# 10. COA-079725-2020

2010-2012 Venable Street

Union Hill

**Rehabilitate two, two-story attached residences, and construct a rear addition.**

Figure 1. 2010-2012 Venable Street, façade

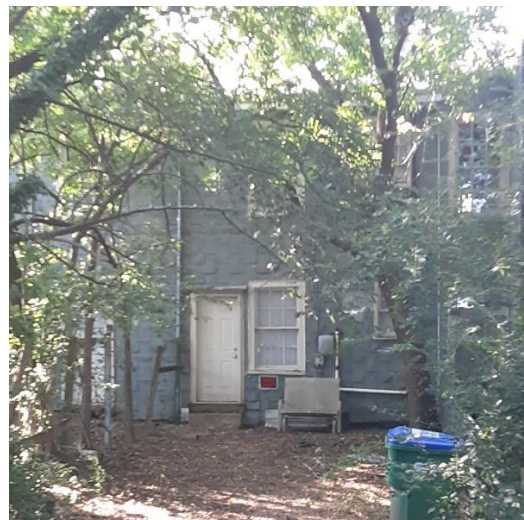
The application states that the existing cornice will be repaired and painted. Staff recommends any replacement of the cornice elements be done in-kind with wood to match the existing design and profile.

The application states that the asphalt siding will be removed and the underlying wood siding will be repaired or replaced in-kind.

The application states that the building will be painted. Staff notes that the attached homes, 2006-2008 Venable Street, will also be rehabilitated and painted. To maintain a cohesive appearance between the buildings, staff recommends one paint color be used for the entire building and be submitted to staff for administrative approval.

- Any replacement of the cornice elements be done in-kind with wood to match the existing design and profile.
- One paint color be used for the entire building and be submitted to staff for administrative approval.
- Any existing box gutters be retained and repaired, and specifications for any new gutters be submitted to staff for administrative approval.
- The replacement railing be a hand-sawn design, to match the historic photograph.
- The second story façade windows at 2010 Venable Street be replaced with 2/2 wood or aluminum clad wood windows with simulated divided lights with interior and exterior muntins and spacer bars between the glass.
